Hope Creek Generating Station  
Facility Operating License No. NPF-57  
NRC Docket No. 50-354

Subject: Supplement to Response to Request for Additional Information  
Request for License Amendment - Extended Power Uprate

### Extended Power Uprate

#### Supplement to Response to Request for Additional Information

Figure 2 –SRV outline showing accelerometer location. Dual SOV identical except for SOV manifold details.

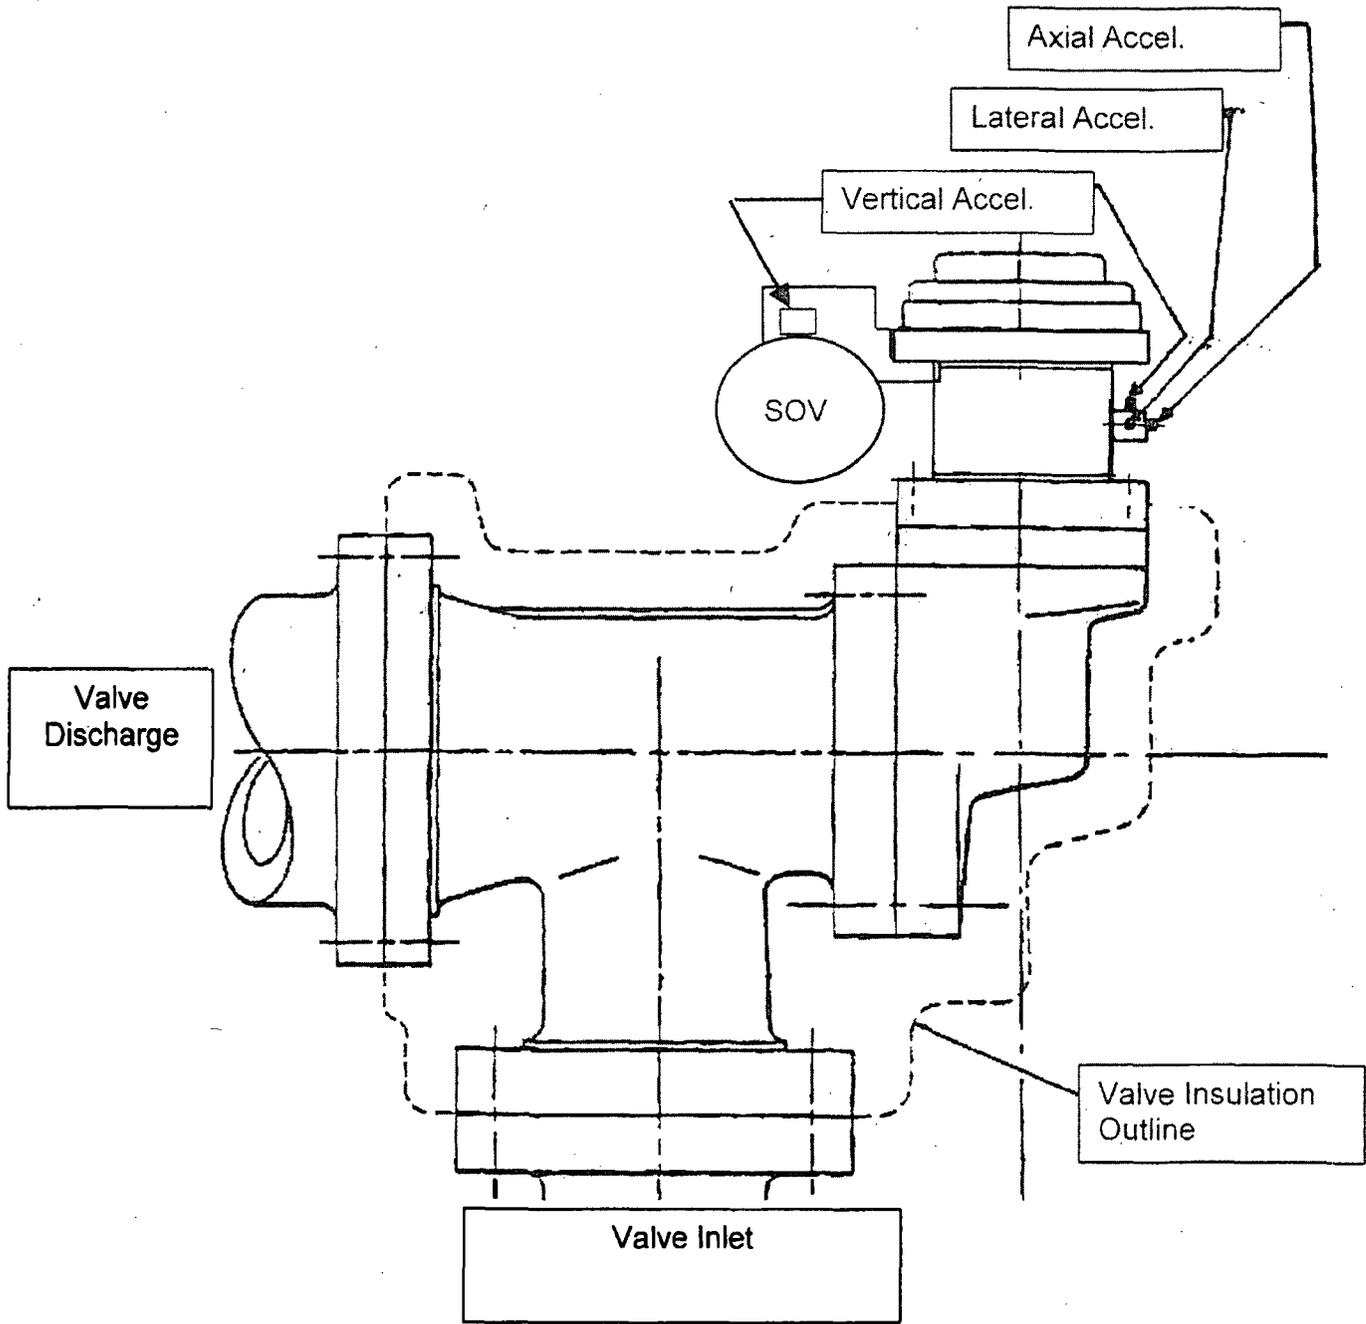
14.74 In the response to RAI 14.19, PSEG states that during power ascension, it is planned to add accelerometers to four safety relied valves (SRVs) to monitor the vibration levels in comparison to predetermined acceptable limits. PSEG is requested to provide information regarding the acceptable limits for valve vibration, which will be implemented in the Power Ascension Test Plan.

Each of the monitored SRVs will be instrumented with three accelerometers. Refer to Figure 2 for the typical arrangement. A mounting block for the accelerometers will be installed on the outside bonnet of the pilot valve housing diametrically opposite the SOV.

Three of the SRVs will have all three accelerometers on the pilot valve mounting block. The fourth SRV, the "A" SRV with dual SOVs, will have the lateral and the axial accelerometers mounted on the pilot assembly. The vertical accelerometer will be mounted on a SOV on the "A" SRV close to the cantilevered end.
